Urgent Field Safety Notice (FSN)

Replacing the power supply unit
for care beds in the Ecofit Xtra range

24.05.2024

Plug-in power supply SMPS - PS1102

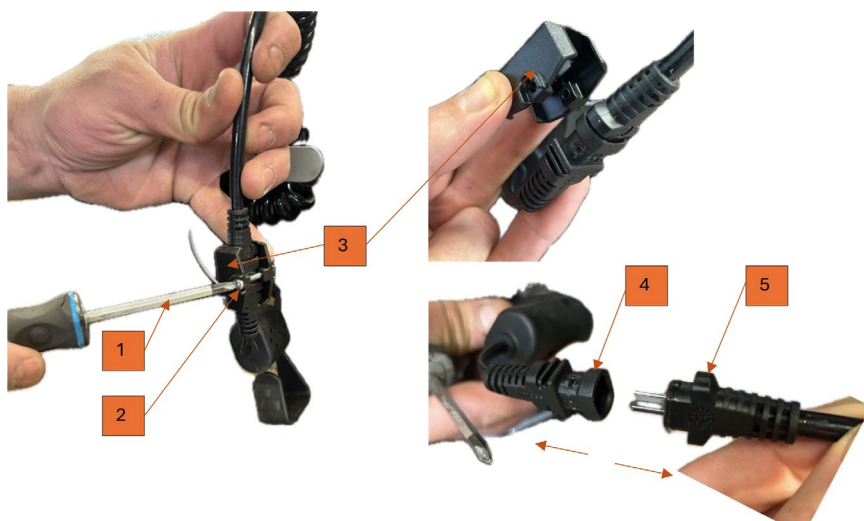
Please replace the MC115L-90-EU power supply unit with the PS1102 power supply unit provided free of charge by tecfor care for care beds from the Ecofit Xtra range in your inventory or during the next maintenance. Instructions for replacement can be found in the appendix to this letter.

1. To remove the previously installed power supply unit, use a screwdriver (1) to loosen the screw (2) on the safety cap of the plug connection.
2. You can then remove the protective cap (3) with little effort.
3. Now release the plug connection (4+5) by pulling in the opposite direction.

1. Take the new plug from the scope of delivery and fit it in the opposite direction as described in the "Disassembly" section.
2. Once steps 3-1 have been carried out, the power supply unit is ready for use and can be reconnected to the mains supply.
